CITY OF PORTLAND BUILDING INSPECTION PERMIT

This is to certify that Yee Cheunglui / Brenden Parker
has permission to Interior renovations, 14' x 14' slab with hot tub surrounded by deck
AT 17 Codman St

Permit No: 10-0686	Issue Date:	CBL: 129 G011001
-----------------------	-------------	---------------------

Subject: 17 Codman St., Pending Building Permit

FRONT

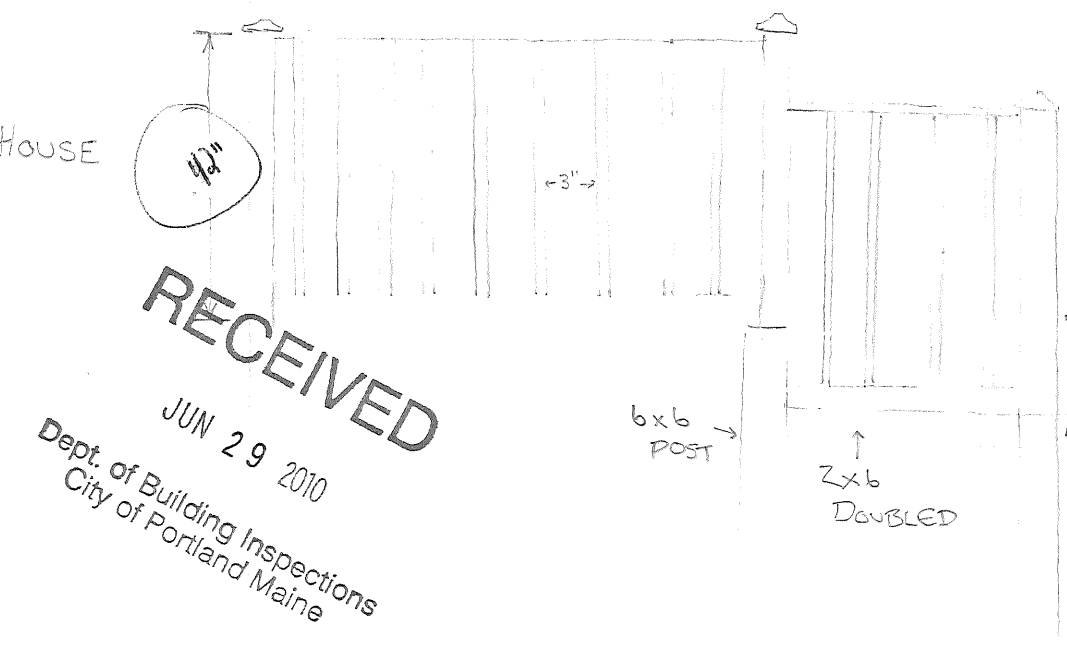
34"-38"
 42"
 11" min Tread
 7" max rise
 NO NOSING
 90°
 (Per
 Brandon B 7/23/10
 At counter

All new railings (guards) to be 42"
 All stairs to have graspable handrail 34"-38"
 both sides with ends returned

BACK DECK FRAMING
(OVERHEAD VIEW)

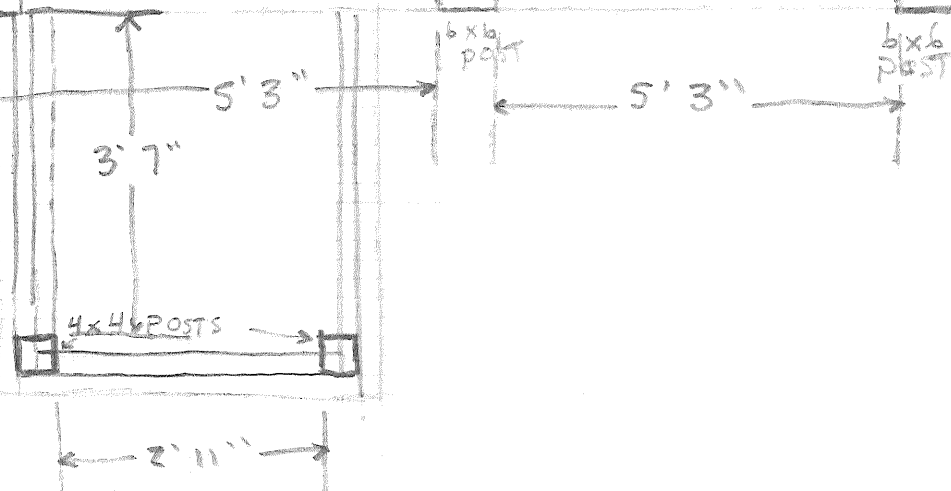
IF-3-2x10
OK SPANS
jmb
max 9'4"

17 CODMAN BASEMENT FLOOR PLAN

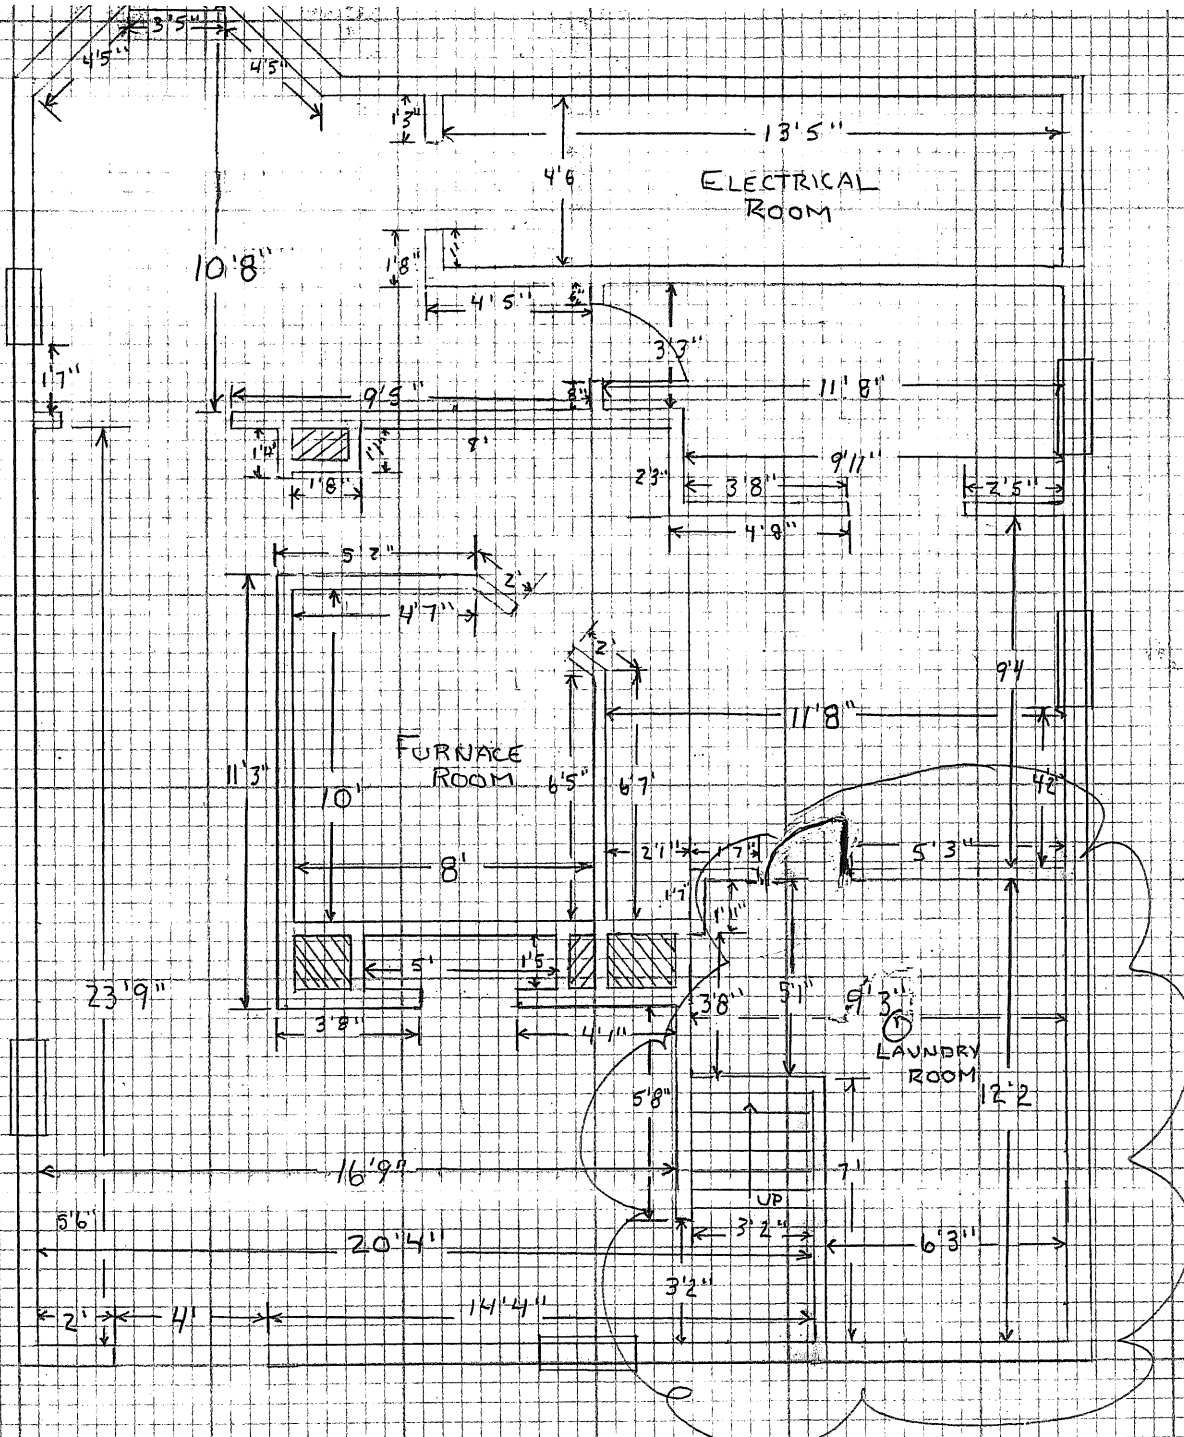
B = 90 min Fire rated door
 Laundry room 5/8" Fire rated
 sheet rock
 walls and ceilings

17 CODMAN - 2ND FLOOR FLOOR PLAN

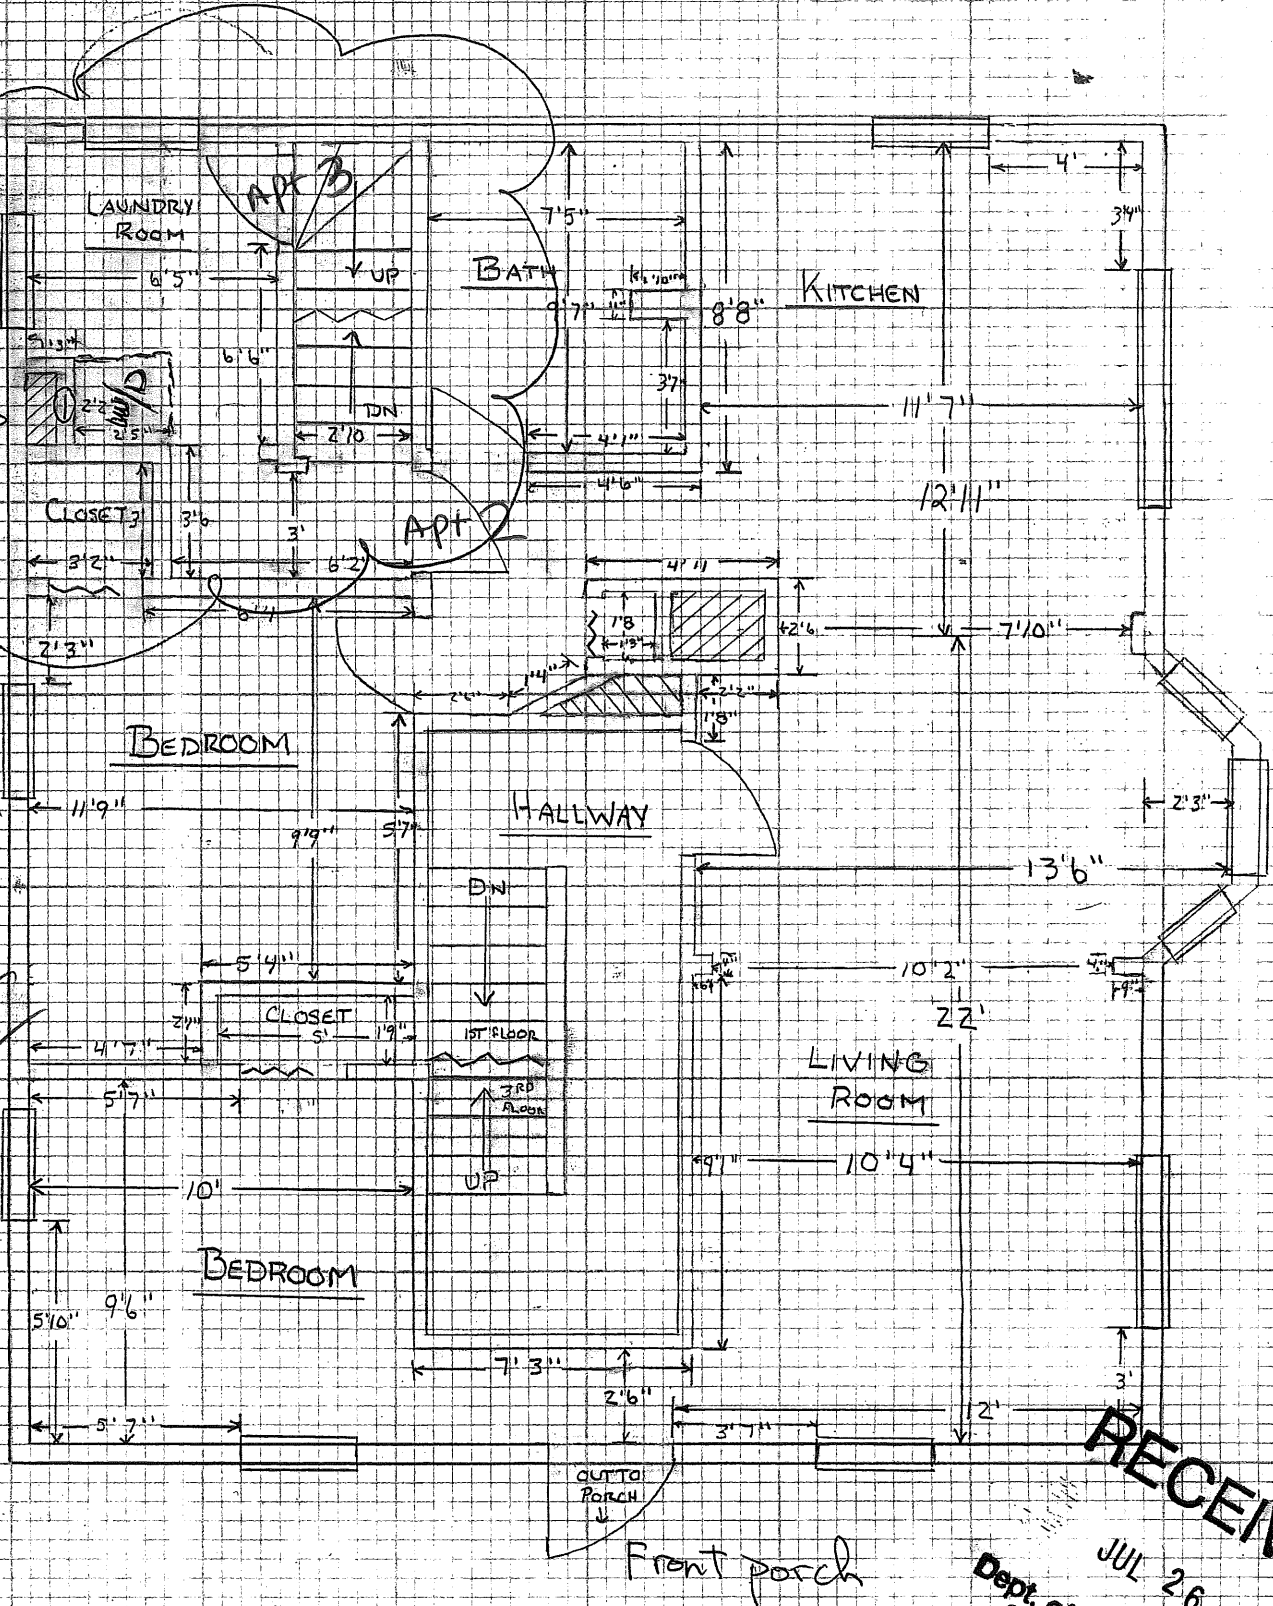
Laundry hookups
 Not Allowed in Common Hallways

2 NEW BRIDGE DETAIL
A5 SCALE: 1"=1'-0"

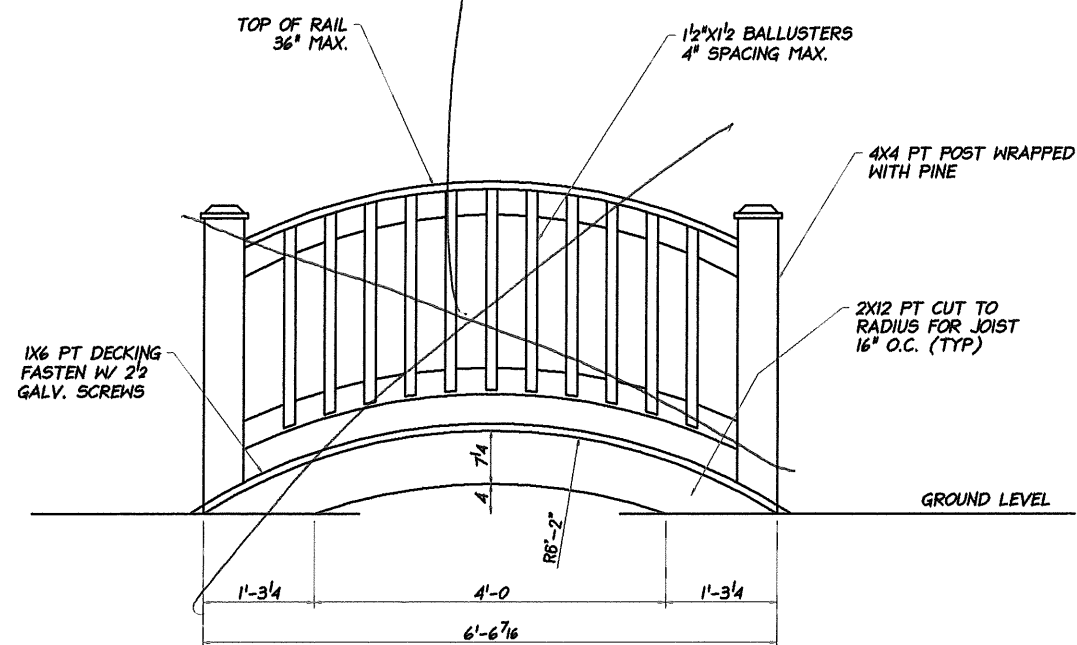
*not part of application
because was structure in front yard
- will be concrete walkway over "paved"*
